File 1992-0070

Name: Sedona Subdivision - Preliminary Plan

REVIEW COMMENTS

ACTIVITY: Preliminary Plan for a Planned Subdivision, Single Family Residential, 4.2 units per acre

PRELIMINARY UTILITY PLAN
 SEDONA SUBDIVISION
 Grand Junction, Colorado

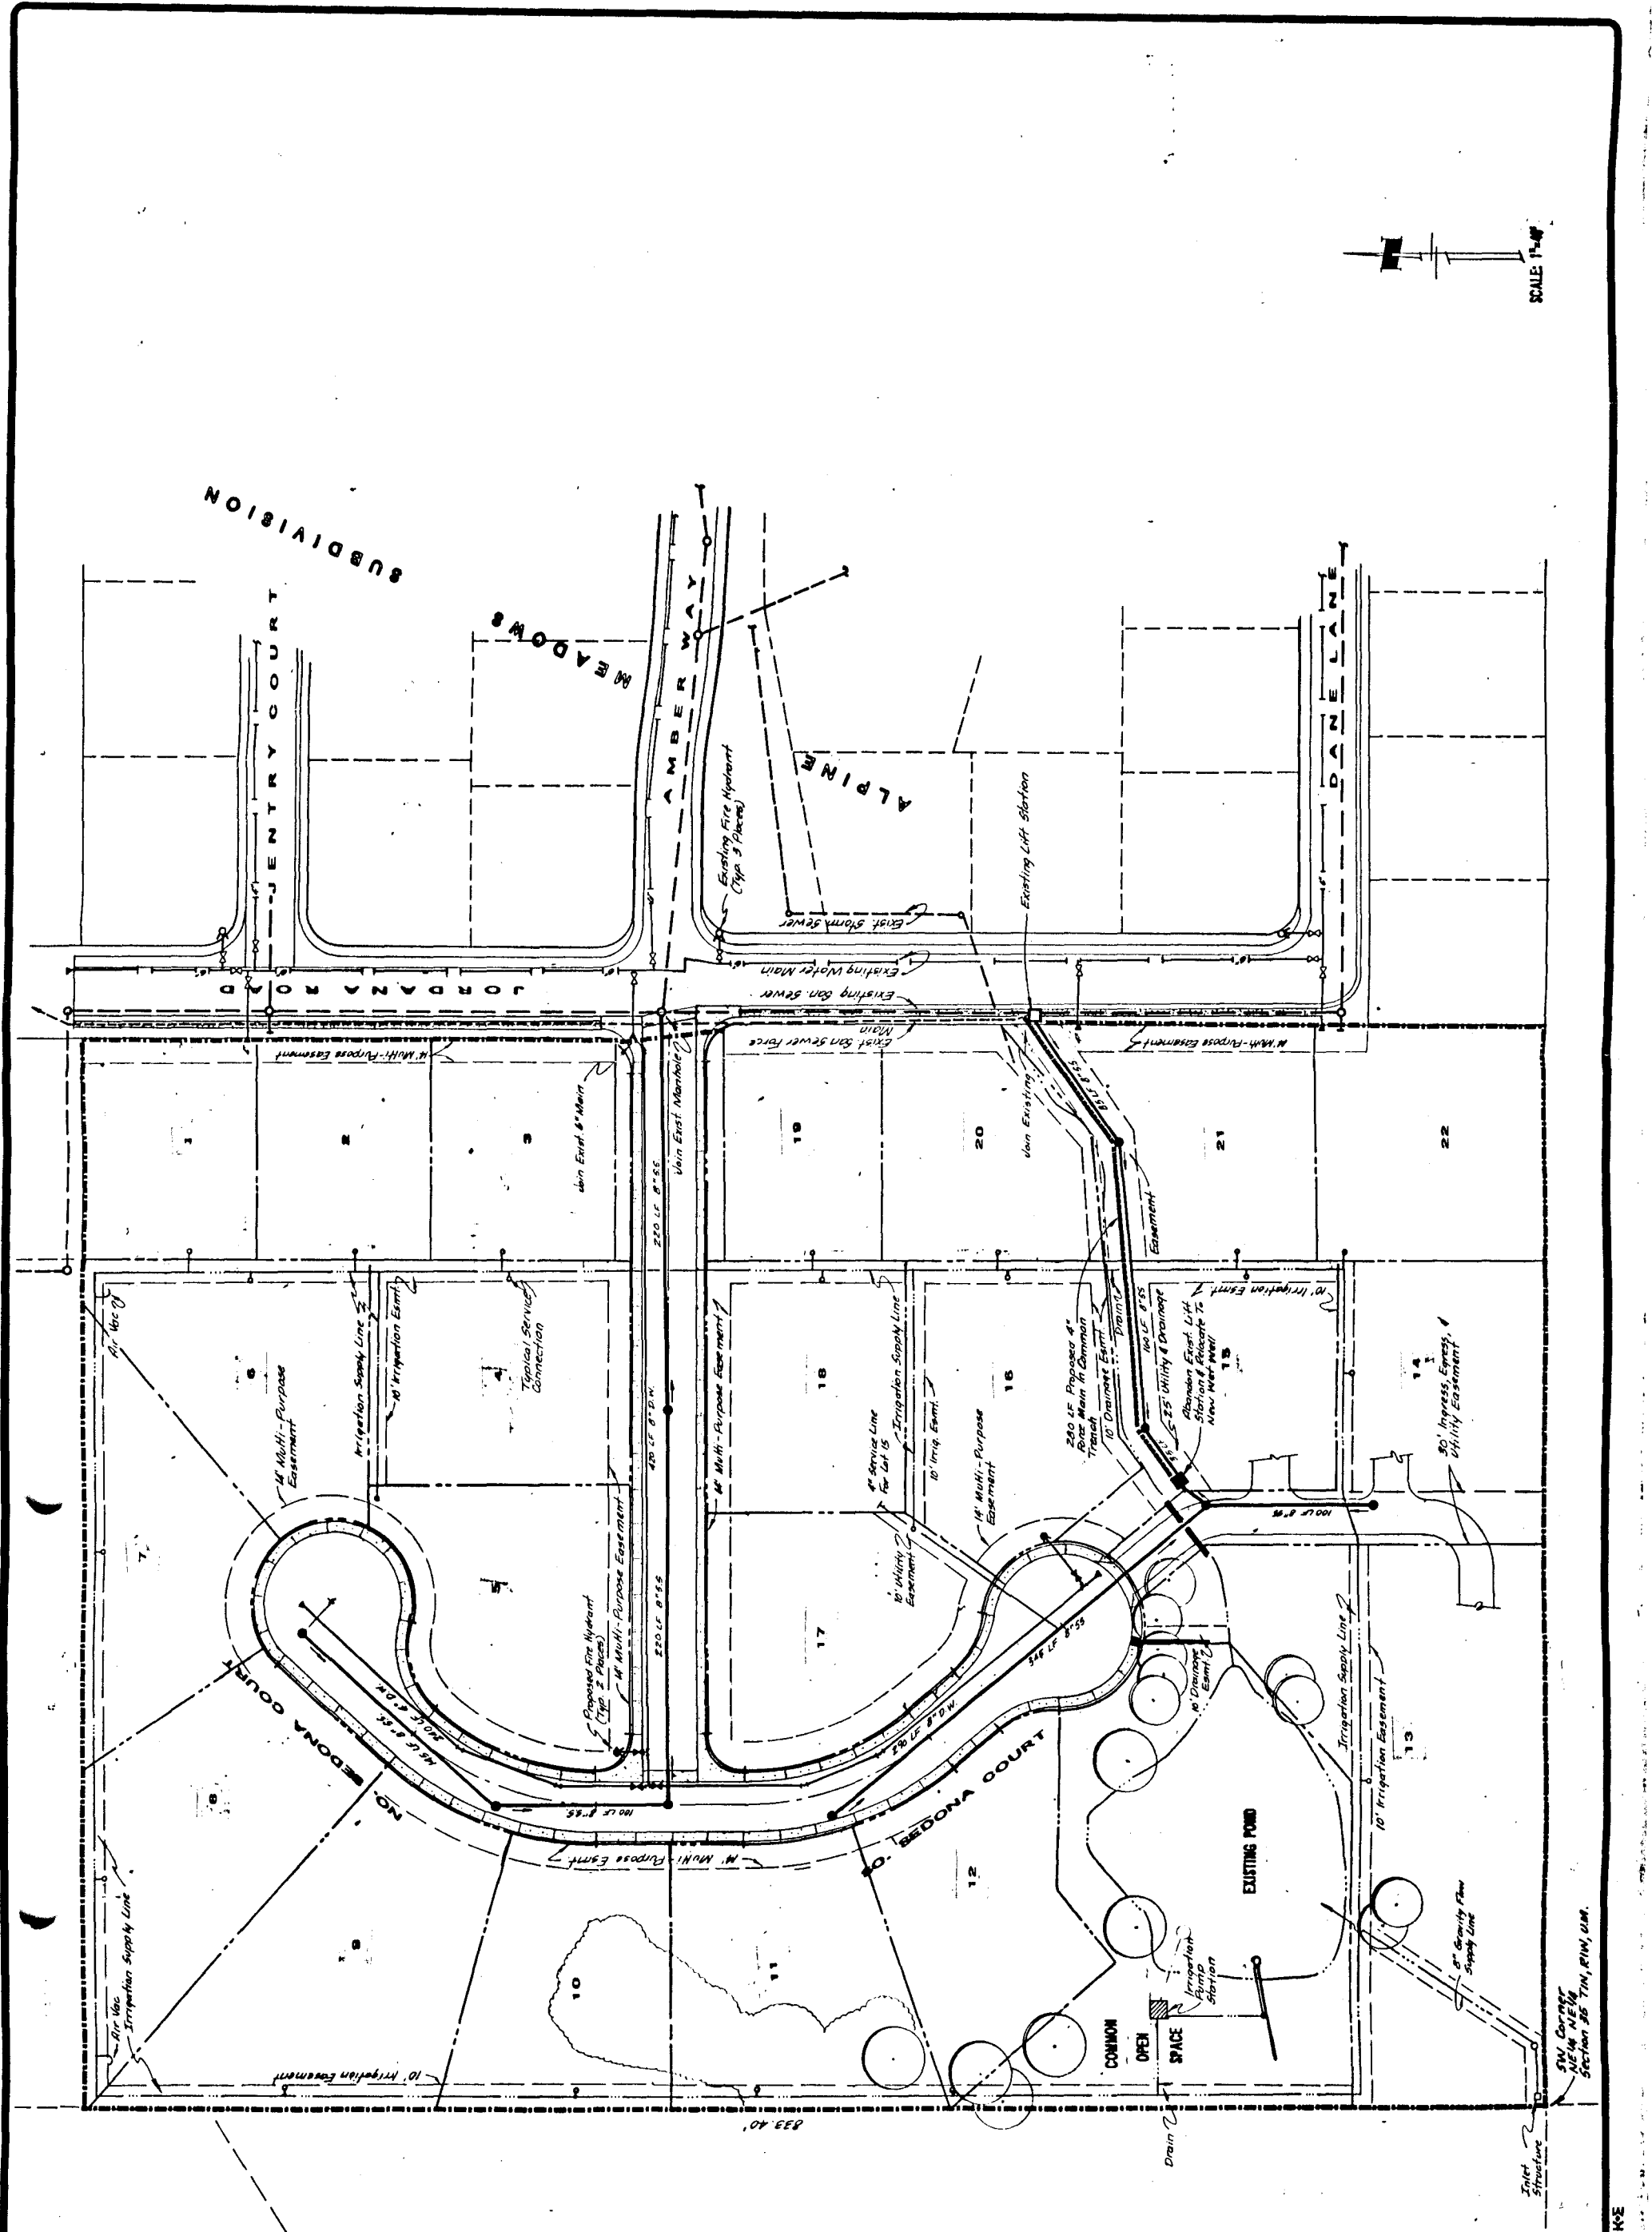
Water - Water supplied by Ute Water. Show pressure at hydrant since line is dead ended at subdivision and does not loop to another supply line. Maximum spacing on hydrants is 250'. Locate hydrant on South Sedona Court nearer to Amber Way.

Sewer - Provide detail for relocating lift station and detail for removing existing wet well. Provide calculations on pump capacity and head to insure lift station has adequate pumping capacity. No other comments at this time.

6. The water line must be looped to provide adequate fire flows. This can be done by extending the water line in Jordanna to H Road.

The Preliminary Utility Plan has not been revised to include the construction of an eight

According to the design engineer for the Alpine Meadows Subdivision, the lift station was originally designed to incorporate the potential for future additional residential units the area. A copy of this analysis was transmitted to the Public Works Department during the design phase of Alpine Meadows. Additional detailed pumping dated will be submitted with the Final Plans. During the lift station relocation process, the wet well will be pumped on an as needed bases. Sewage pumped from the wet well will be delivered to the Persigo Treatment Plant. The proposal calls for the modification of the wet well in order that it will ultimately serve as a gravity flow manhole.

PRELIMINARY SITE DEVELOPMENT PLAN FOR:
BEDONA SUBDIVISION
Grand Junction, Colorado.

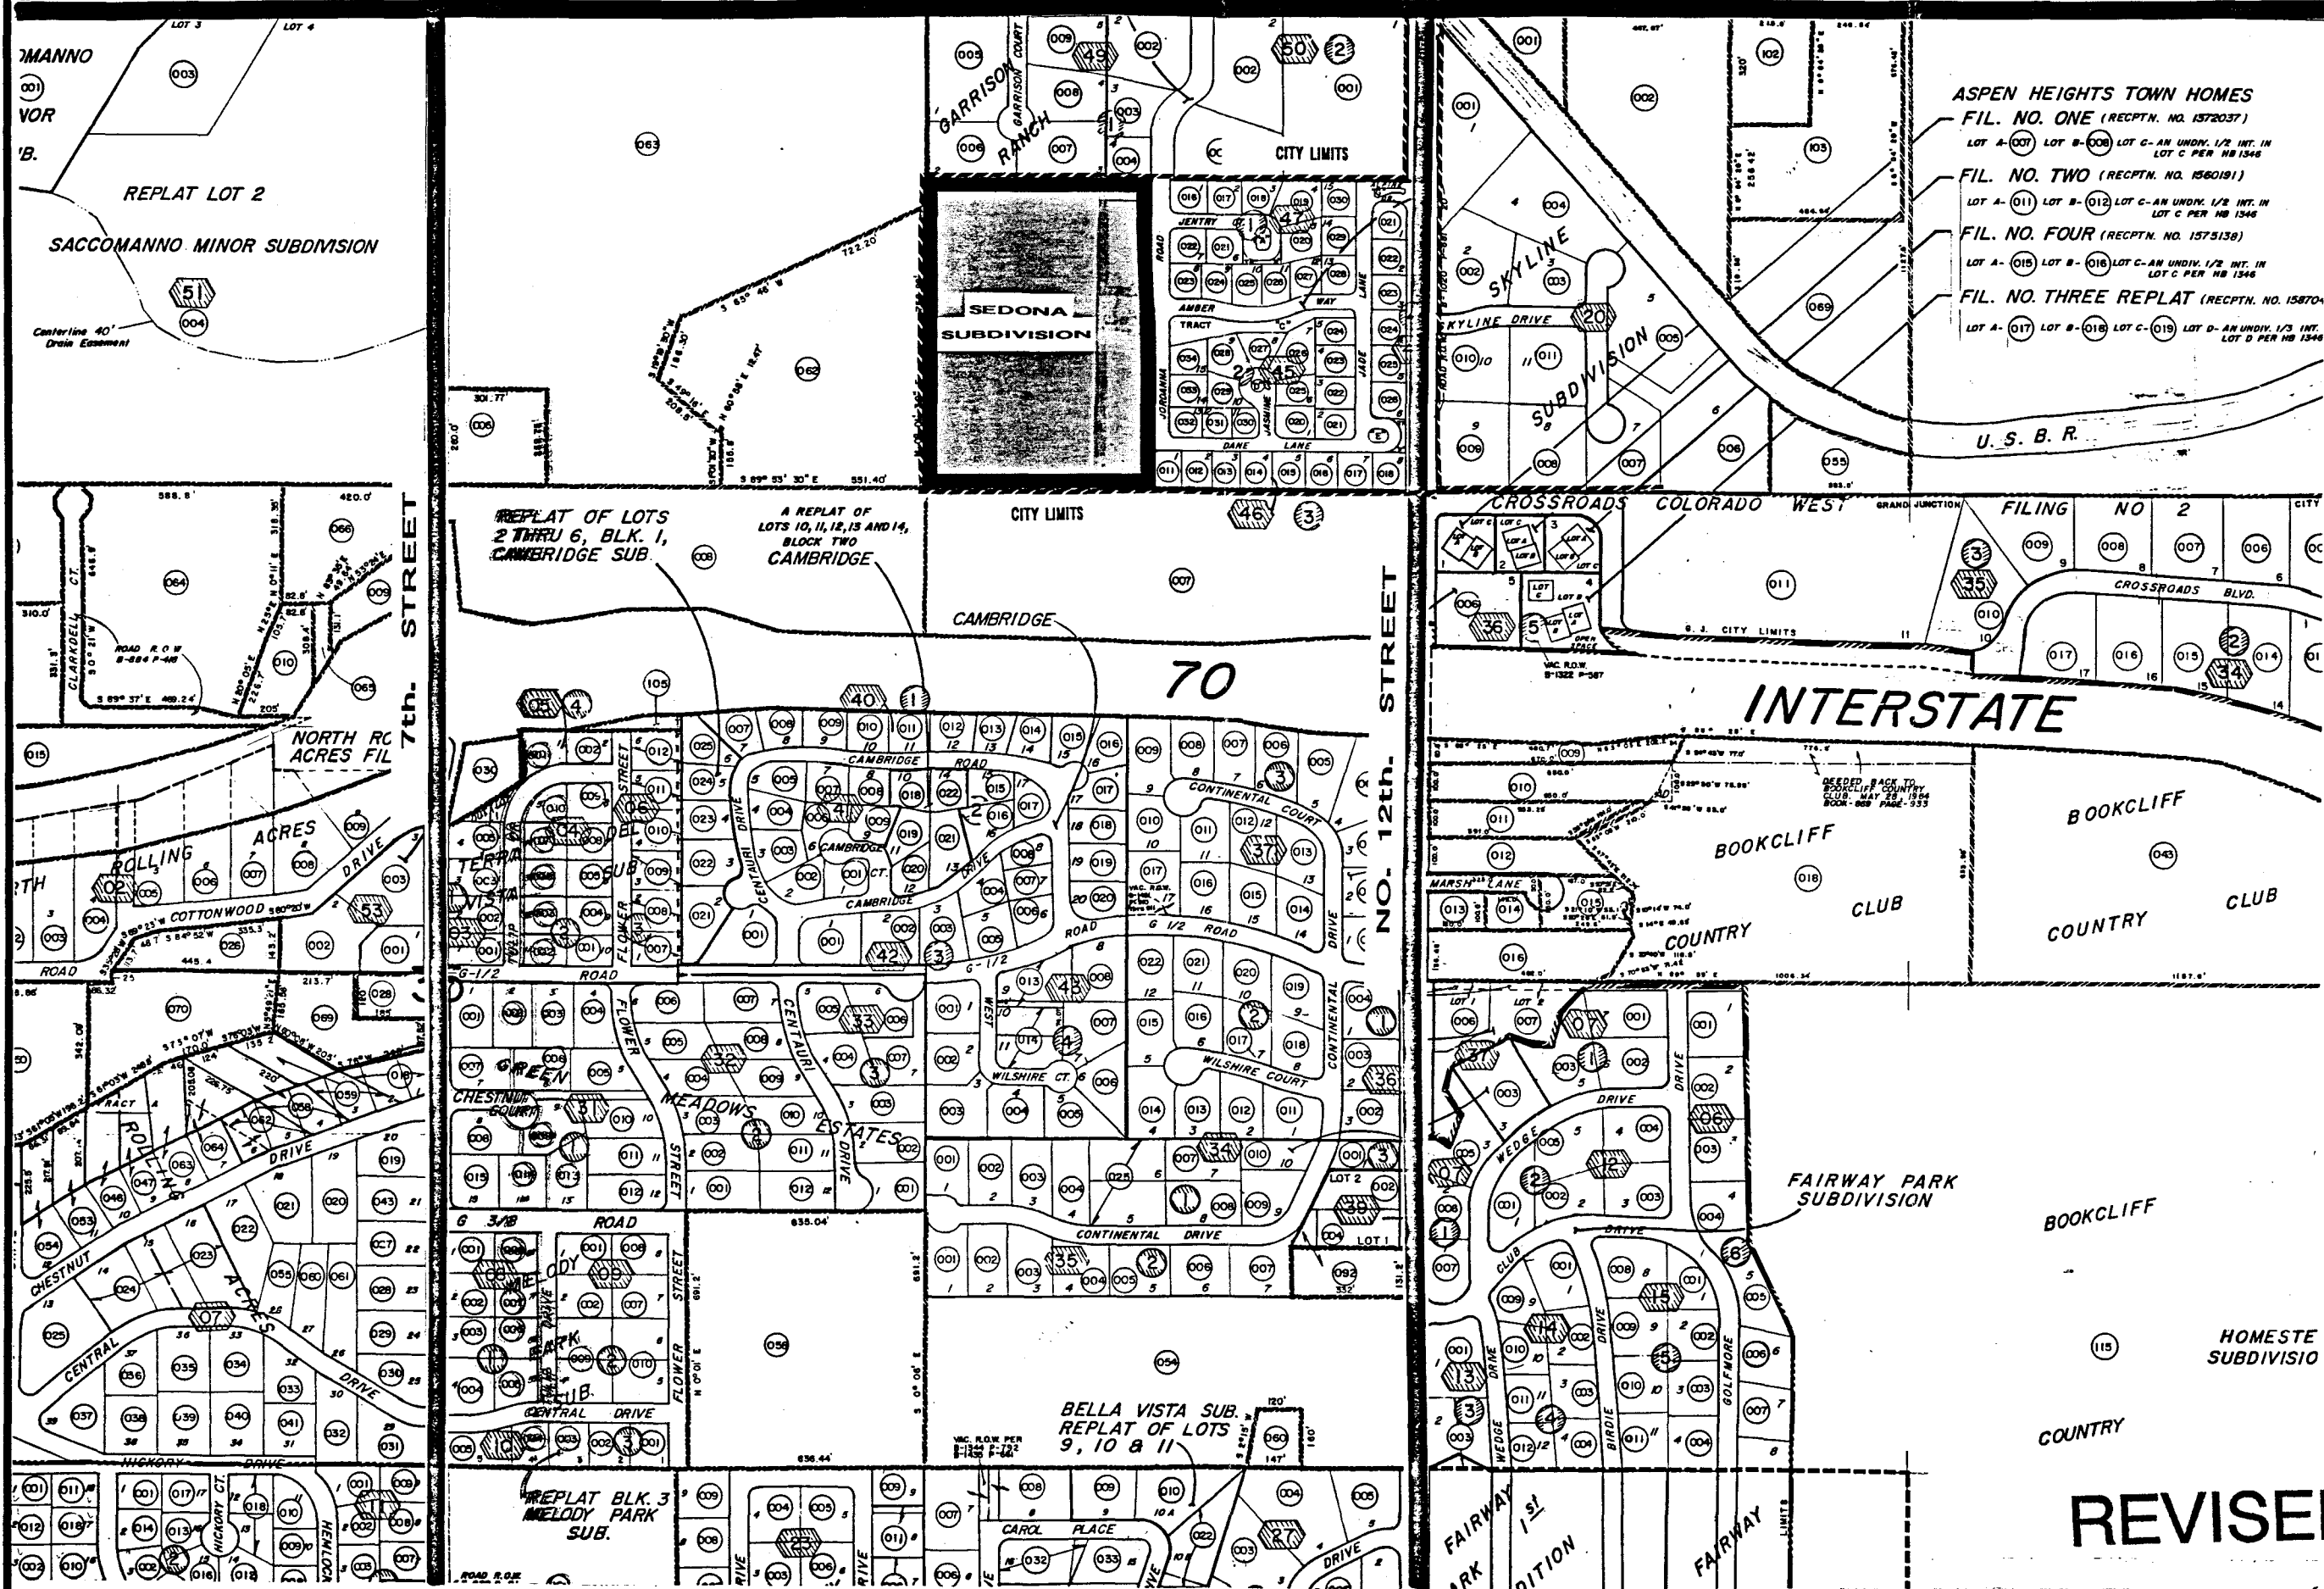
1. All recommendations in soils report must be adhered to for all construction.
2. South Sedona court must be extended to the south to provide direct access to all lots including lots 13 & 14. In addition, ROW must be dedicated to the south to provide access to the adjacent property to provide for a better traffic circulation for the entire area.

5. The parcel directly to the west is landlocked and access must be provide to that lot. Extending Amber Way to the parcel would probably be the best way to handle this. We will support the option of only requiring dedication of right-of-way and not requiring improvements to this additional ROW of Amber Way. Future development on the parcel currently landlocked would be required to construct the street improvements and tie into the intersection of Amber Way and Sedona Court.

1. Tract A has been designated for private ownership as a private drive and utility easement for Lots 13,14 and 15.
2. A 42 foot undeveloped road right-of-way has been designated for future extension to the west between Lots 10 and 11.
3. An eight inch water main stub has been added to the utility plan at the new right-of-way dedication.
4. The Grading Plan has been revised to reflect the drainage swale along the west subdivision boundary.
